# ADDENDUM NO. 3

**August 19, 2022**

## **Additions and Renovations Hawthorne Elementary School**

ADDENDUM NO: 3

**DRAWING NUMBER:**  
**S102**

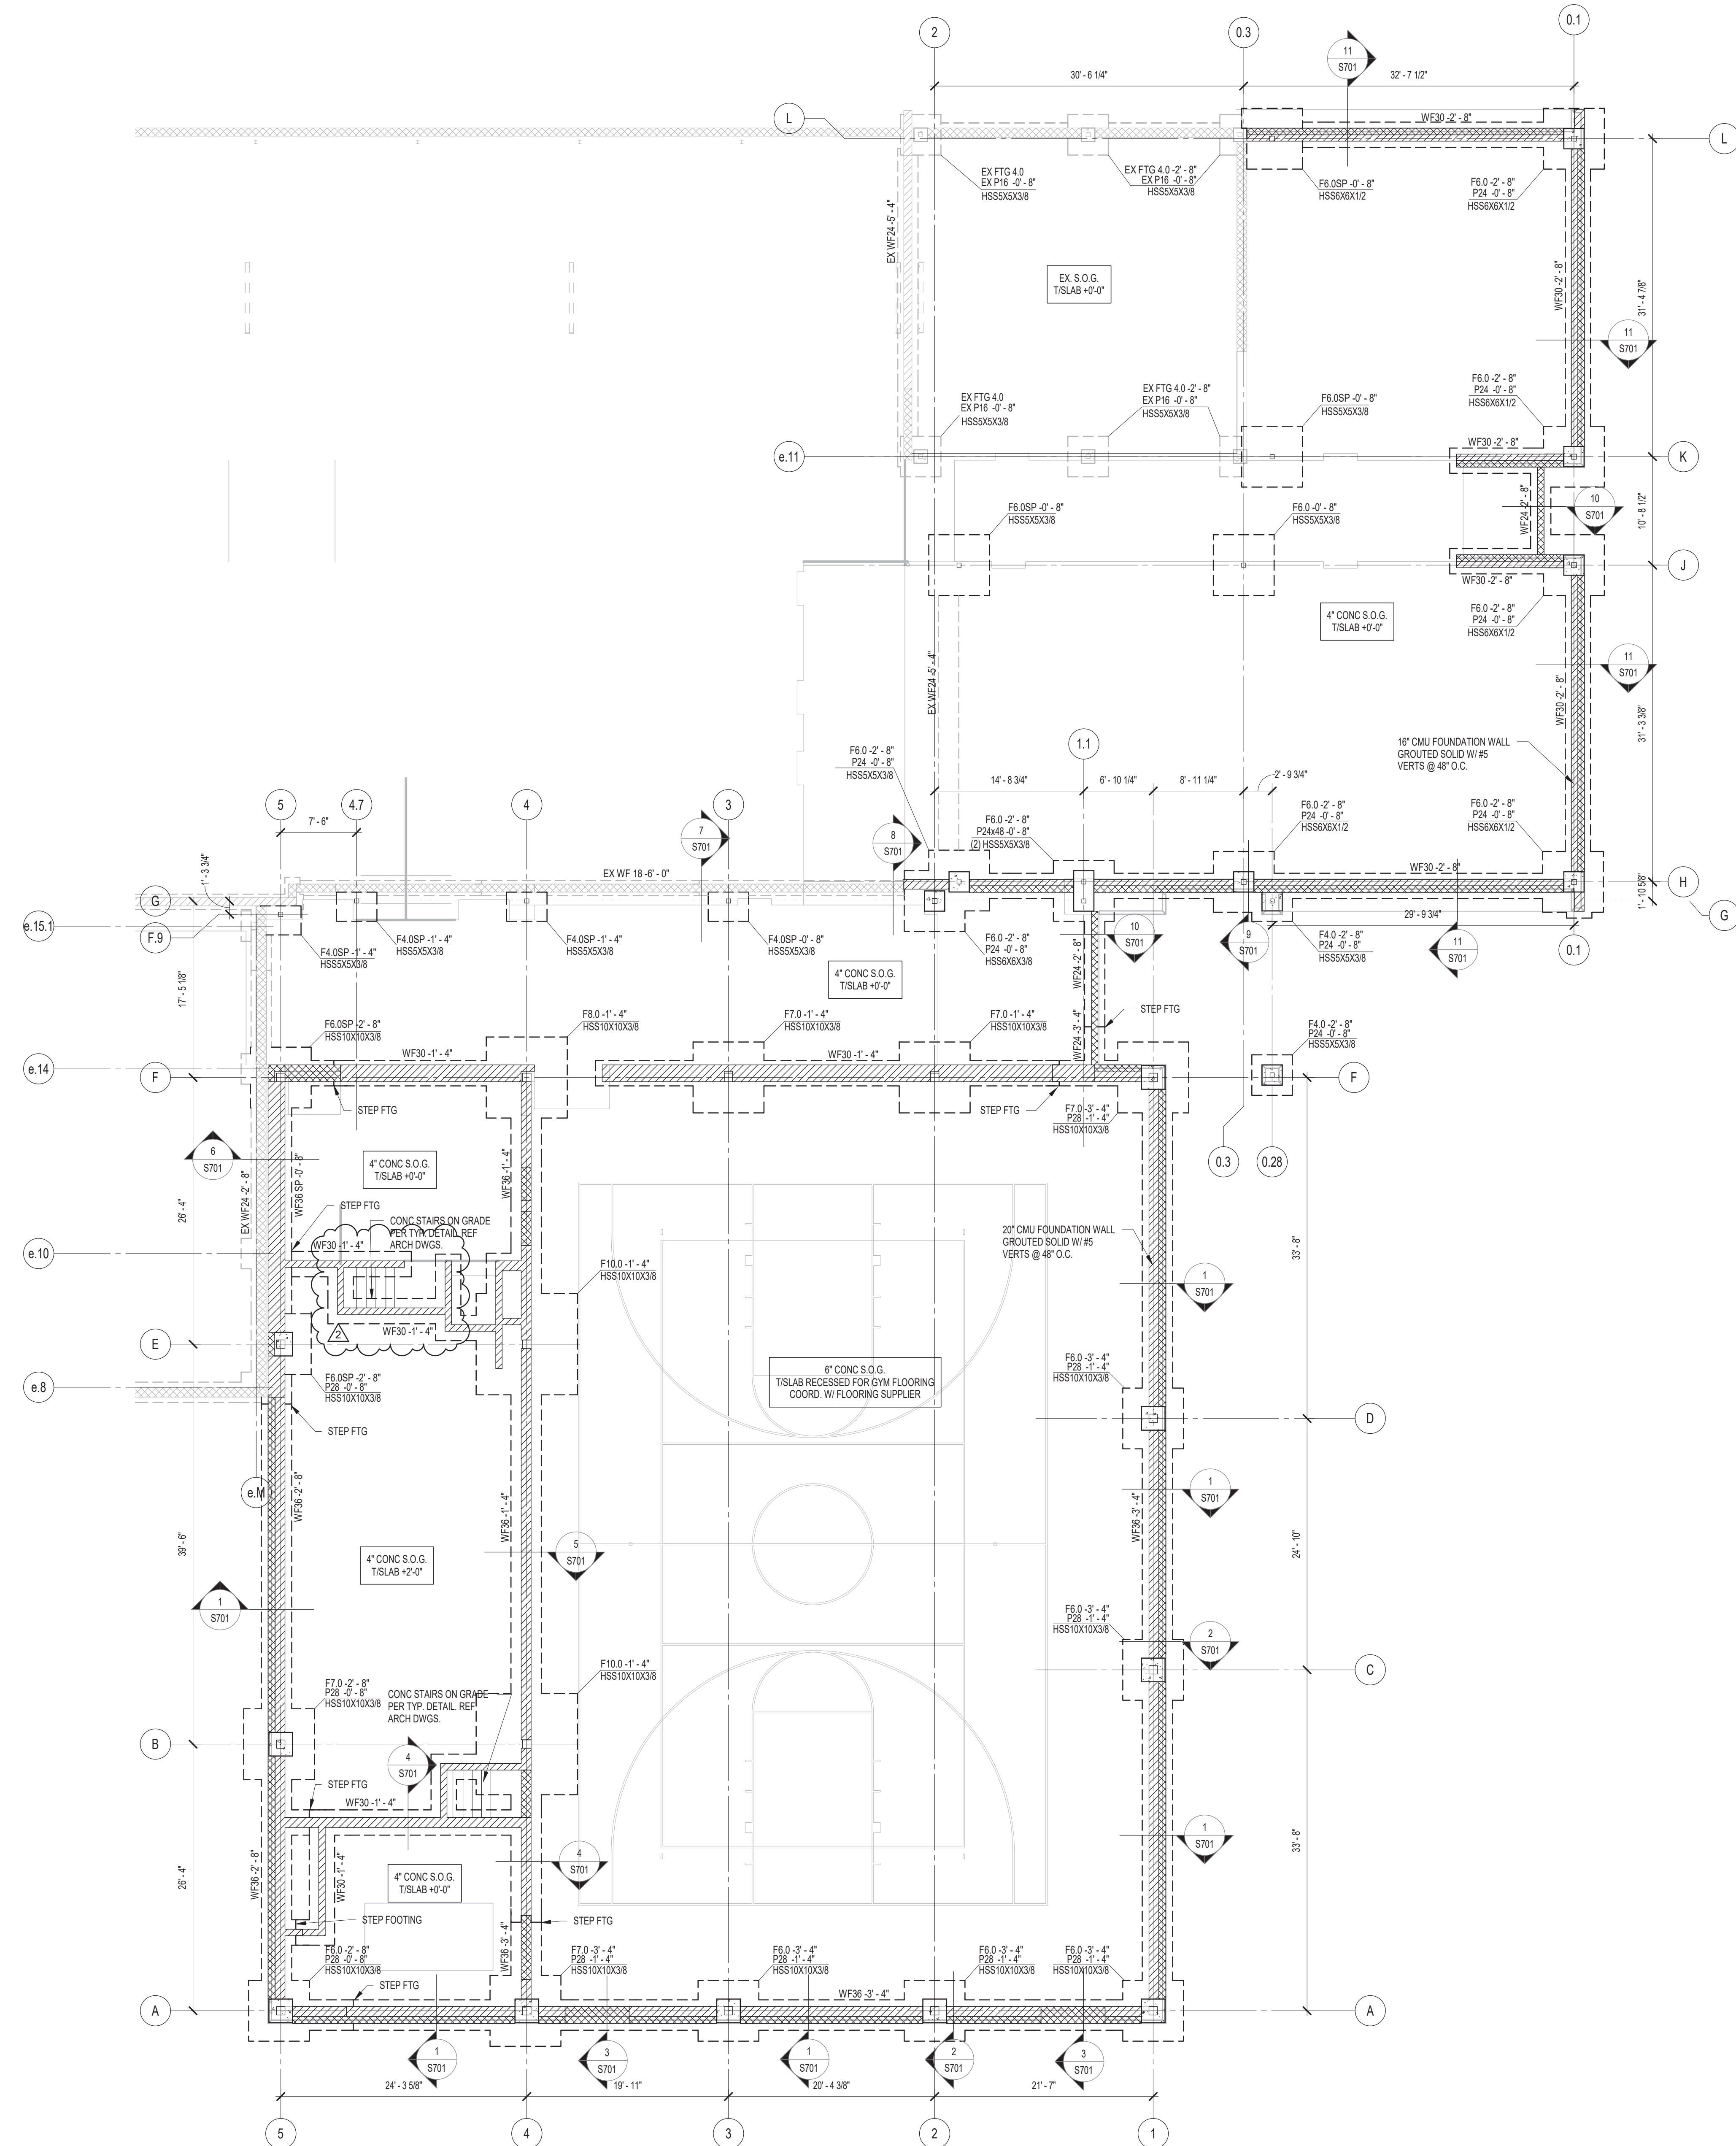
### **Drawing S102 Low Roof Framing Plan**

1. Additional steel beam lintel at stage entrance.
2. Added note regarding the concrete curb around the perimeter and all openings at the new mechanical mezzanine.

DRAWING NUMBER:  
**S101**

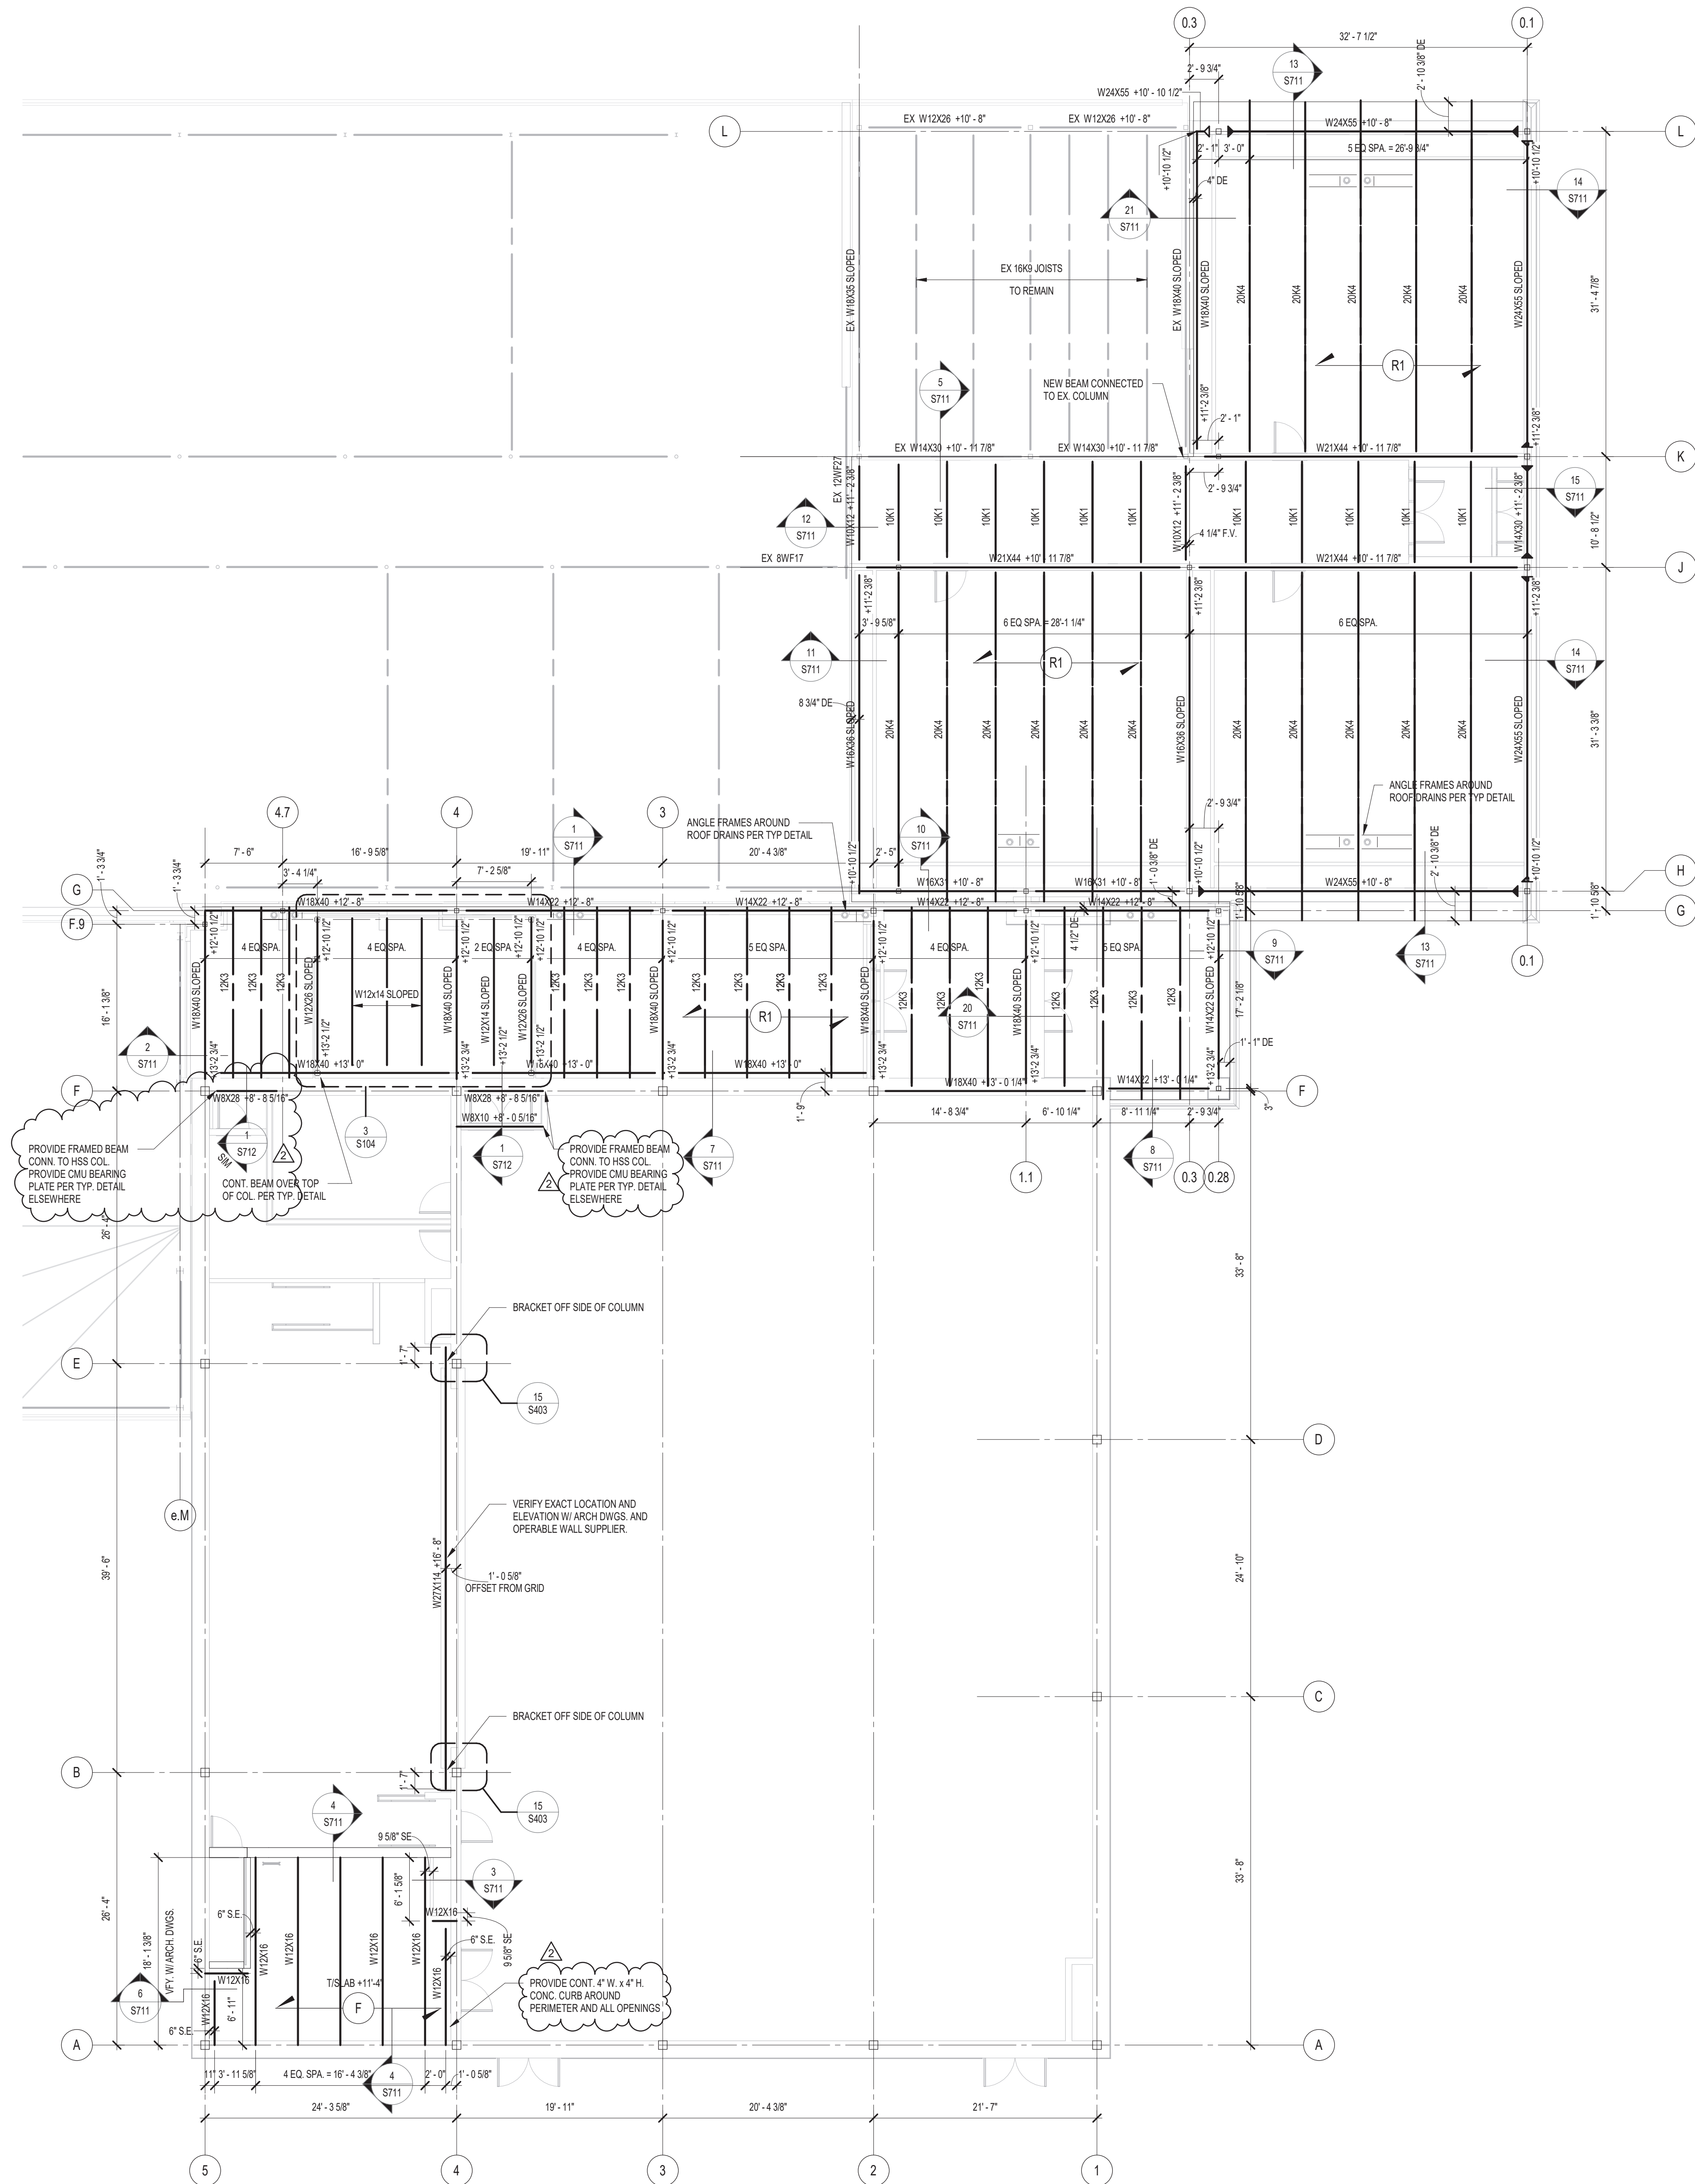
### **Drawing S101 Foundation Plan**

1. Adjust CMU wall locations at concrete stairs.

**1 SECTION**  
 3/4" = 1'-0"

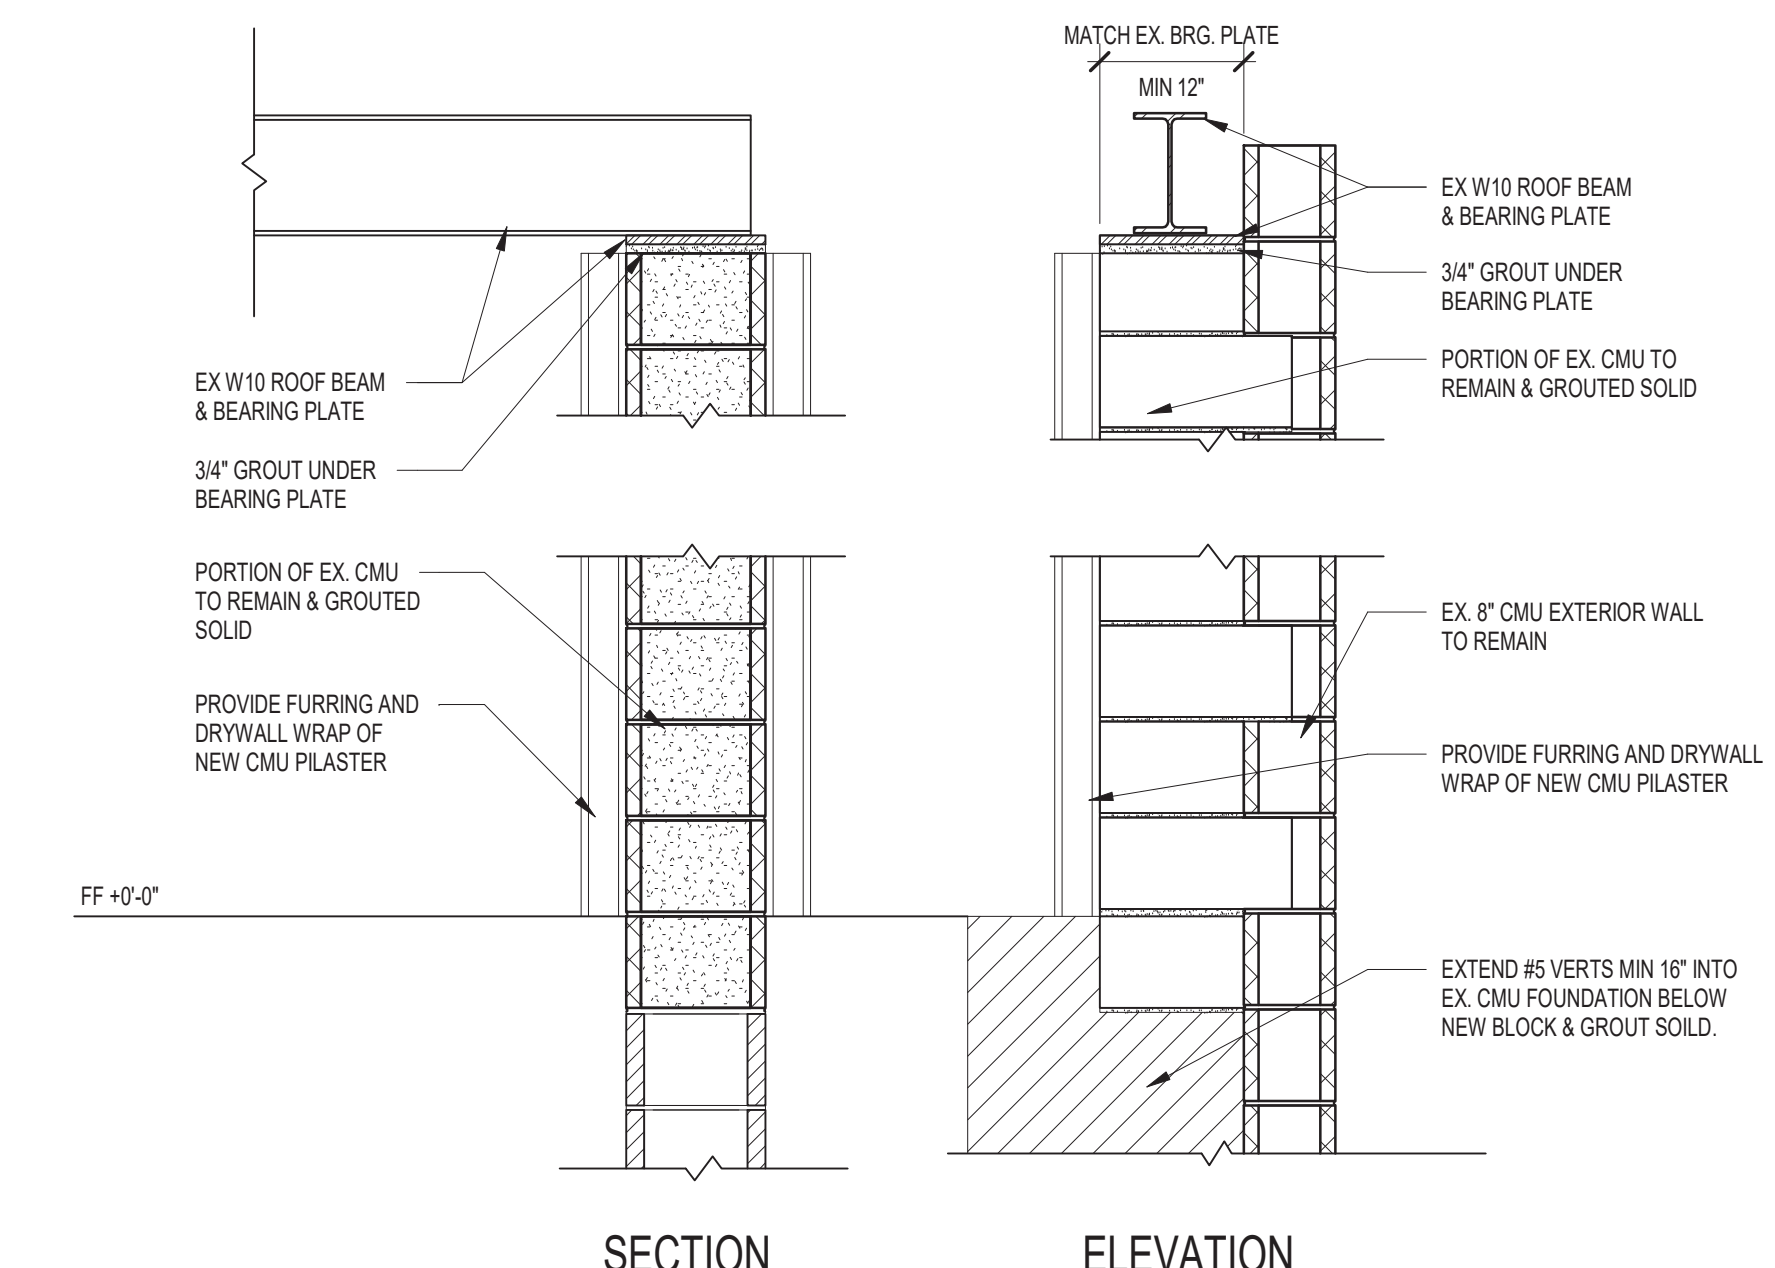
### **Drawing S712 Framing Sections and Details**

1. Modify Section 1/S712.
